No. UPMRC/CE Contract/ LKGS-01/2024

### ADDENDUM-01

**Tender Title/Name of work: Tender LKGS-01:** Detailed Geo-Technical Survey of East-West Corridor (Charbagh to Vasantkunj) including Depot at Hardoi Road for Lucknow Metro Rail Project Phase 1B.

**Summary Sheet of Addendum No.01: LKGS-01**

UTTAR PRADESH METRO RAIL CORPORATION LTD.			
DETAIL OF TEMPORARY BARRICADING- 2M HT			
REV.	SCALE	STATUS	TENDER DRAWING
DATE			DATE/PATE

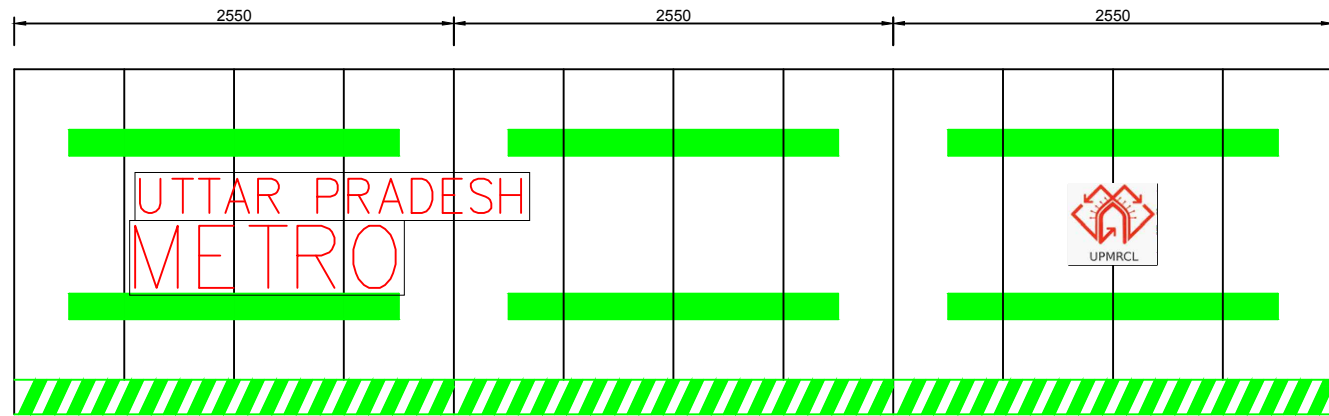
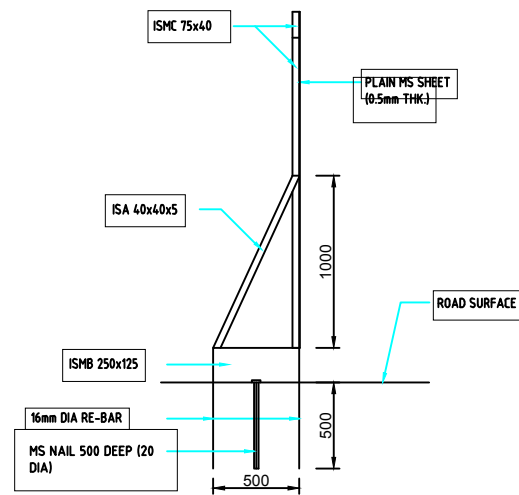
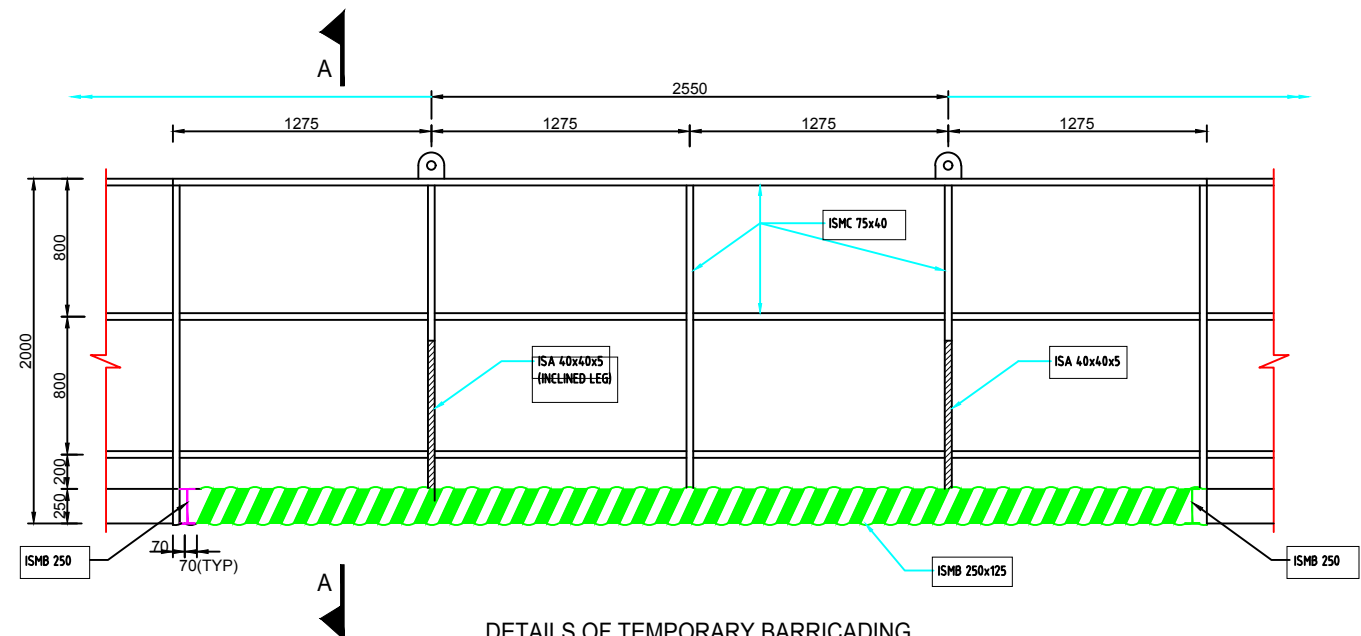
2	Volume 1, Chapter 4 (ER & OS), Clause 3.7.5, Page 90	3.7.5 At least 5% soil testing as directed by Engineer shall be conducted by Laboratory holding current accreditation under International Standard Organisation/Bureau of Indian Standards.	<del>3.7.5 At least 5% soil testing as directed by Engineer shall be conducted by Laboratory holding current accreditation under International Standard Organisation/Bureau of Indian Standards.</del>	Please refer Annexure -01, UPMRC/LKGC-01/Vol-1/ER & OS Page no. 90R
3	Volume 1, Chapter 5 (Tender Drawings)	Volume 1, Chapter 5 (Tender Drawings)	2 No's of additional drawings "Detail of temporary barricading 2M HT" & "Detail of temporary barricading - 1M HT" are provided as Page 1 & Page 2 of Annexure-02.	Please refer Annexure -02, UPMRC/LKGS-01/Volume-1/Tender Drawings
